**MONTGOMERY COUNTY HISTORIC PRESERVATION COMMISSION**  
**STAFF REPORT**

<b>Address:</b>	7118 Carroll Ave., Takoma Park	<b>Meeting Date:</b>	9/1/2021
<b>Resource:</b>	Outstanding Resource <b>Takoma Park Historic District</b>	<b>Report Date:</b>	8/25/2021
<b>Applicant:</b>	Alberto Ramos	<b>Public Notice:</b>	8/18/2021
<b>Review:</b>	HAWP	<b>Tax Credit:</b>	n/a
<b>Permit No.:</b>	963287	<b>Staff:</b>	Dan Bruechert
<b>Proposal:</b>	Rooftop solar array

**PROPOSAL**

Figure 1: 7118 Carroll Ave., Takoma Park

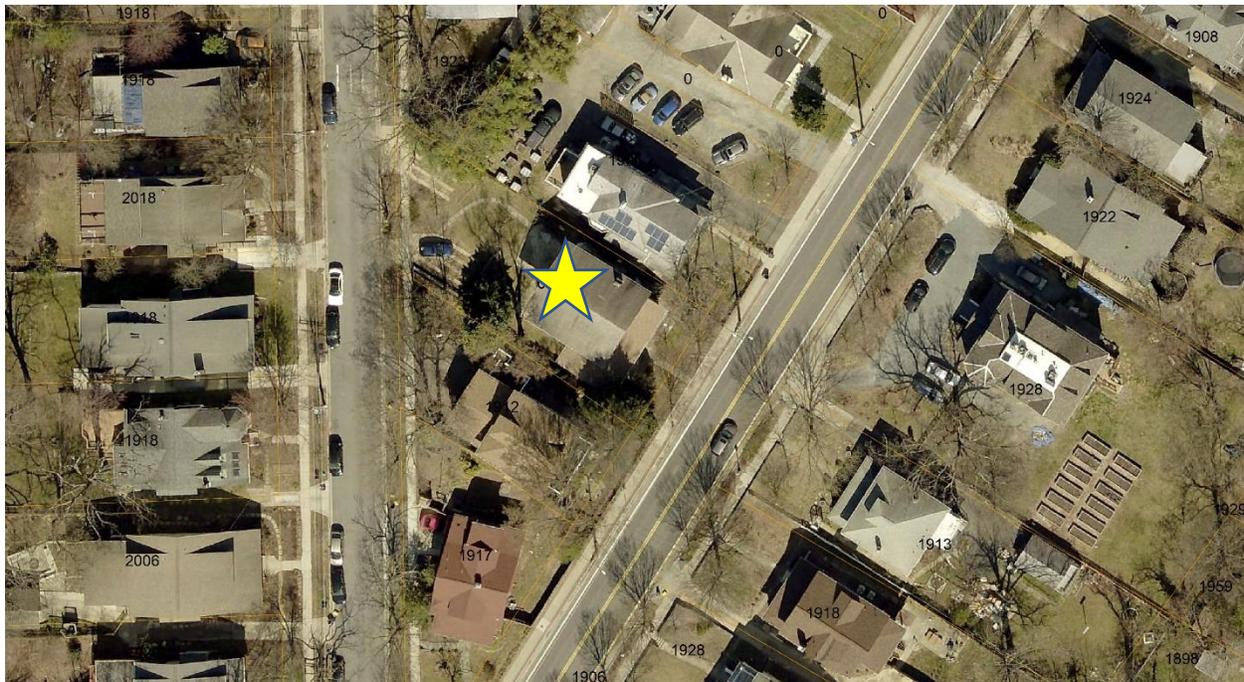
The subject property is a two-story house with a front gable roof and a wrap-around porch with a port-cochere. Though the house faces Carroll Ave., vehicles access the property from Park Ave. The applicant proposes installing a total of fifty-eight solar panels on the roof of the subject property. Thirty-three of the panels are to be installed in a single array on the left (south-facing) roof slope, and the remaining twenty-five will be installed on the right (north-facing) roof slope.

Staff finds that the proposal includes a large number of solar panels, but nonetheless finds that the panels will not significantly detract from the historic character of the subject property or surrounding district. In evaluating the proposal, Staff first considers the preferred locations for solar panels. The lot is not large enough for a ground-mounted array, nor is there an accessory building in the rear of the property. The house has not been added onto, so there is not a building addition that can be utilized. Finally, because the roof of the subject property is a front gable, there is not a rear slope to install the panels so that they would be less visible from the public right-of-way (again, because the house has access from both Carroll and Park Aves., any alterations to a rear roof slope would still be visible from a right-of-way). Based on this analysis, Staff concludes that the only location for solar panels at the subject property is on the roof.

Staff further finds that the asphalt-shingled front gable roof is not architecturally significant and the proposed work will not permanently damage historic materials or the historic design. Staff finds that both the left and right roof slopes will be visible from the right-of-way.

The evaluation then comes down to the configuration and placement of the proposed panels. Staff finds that the most successful solar installations occur when the solar panels are installed in a single square or rectangular configuration. This simple rectilinear form better blends into the background instead of drawing visual attention by including additional corners and gaps in the array. The panels on the left roof slope will be installed in an 11 × 3 panel configuration, while the panels on the right are arranged in a 2 × 8 configuration at the front with an additional nine panels in a 3 × 3 arrangement at the rear. Staff finds that even though these panels will be visible from certain angles from the right-of-way they will not detract from the historic character of the house or surrounding district. Unlike the previously reviewed solar panel case involving an Outstanding Resource, (14 Crescent Place, Takoma Park<sup>1</sup>) the entirety of one roof slope is not visible from the right-of-way. Only partial slopes are visible at the subject property. Staff also notes that the neighboring property at 7120 Carroll also installed a roof-mounted solar array which was limited to the left roof slope. This was done for two reasons. First, the Solar Policy had not been adopted by the HPC when this HAWP was submitted. Second, the open lot to the right of 7120 Carroll makes the entirety of the right roof slope visible from the right-of-way. Staff finds that while the proposed array includes a large number of panels, the configuration and placement does not detract from the character of the house or surrounding district and recommends the HPC approve the HAWP.

Staff recommends the HPC **approve** the HAWP.
